Cork NW Regeneration Quarter - Phase 4A

Stage 1 Road Safety Audit

Cork City Council

Client	Cork City Council
Project	Cork North West Regeneration Quarter – Phase 4A
Job number	5204404

Figure 2-4 – Pedestrian Crossing located away from the Desire Line

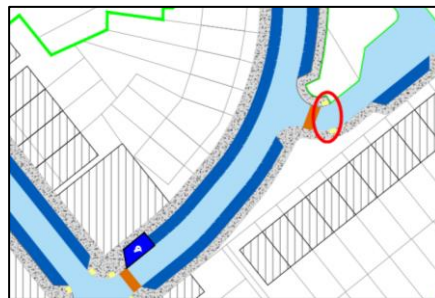
The pedestrian crossing at this location does not appear to align with the likely pedestrian desire line. This could result in pedestrians crossing away from the designated location, which could catch a driver unaware resulting in a risk of a vehicle / pedestrian collision.

Figure 2-6 – Potential Adverse Camber

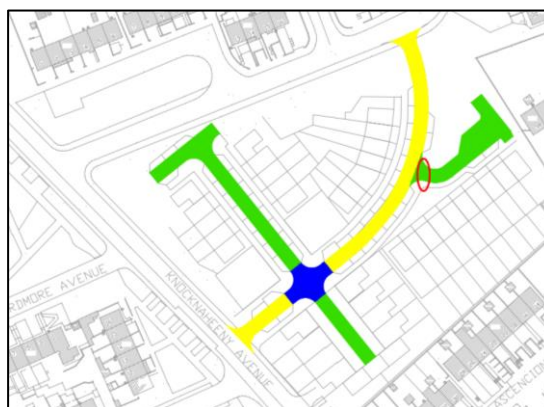
With the downhill gradient on the Link Road creates the potential for the introduction of adverse camber at the junction with Side Road 10. Adverse camber can lead to several difficulties including drainage issues, uncomfortable ride quality for drivers and difficulty in manoeuvring large vehicle such as refuse trucks.

Figure 2-7 – Vehicle Speed on Knocknaheeny Avenue

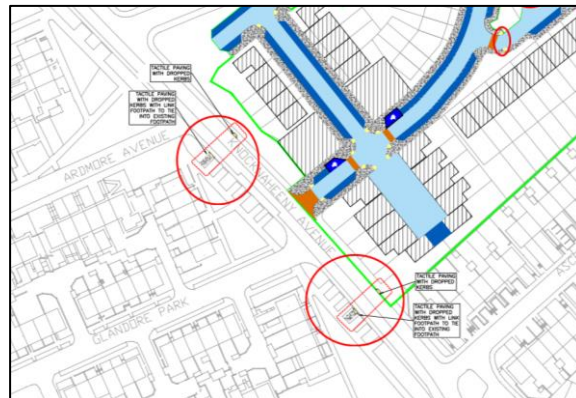
During the site visit several vehicles were observed travelling at a higher than appropriate speed on Knocknaheeny Avenue in the direction of Harbour View Road. The scheme proposes to introduce uncontrolled crossings at two locations on Knocknaheeny Avenue. Pedestrians crossing at these locations are potentially at risk of collision.

It is recommended that the designer should consider providing some advance warning measures in association with the introduction of the pedestrian crossings, which increase driver awareness of the pedestrians at the crossings and thus encouraging them to travel at an appropriate speed on approach. These measures could include additional advance warning signage, modified road markings and ensuring adequate public lighting is provided at these locations.
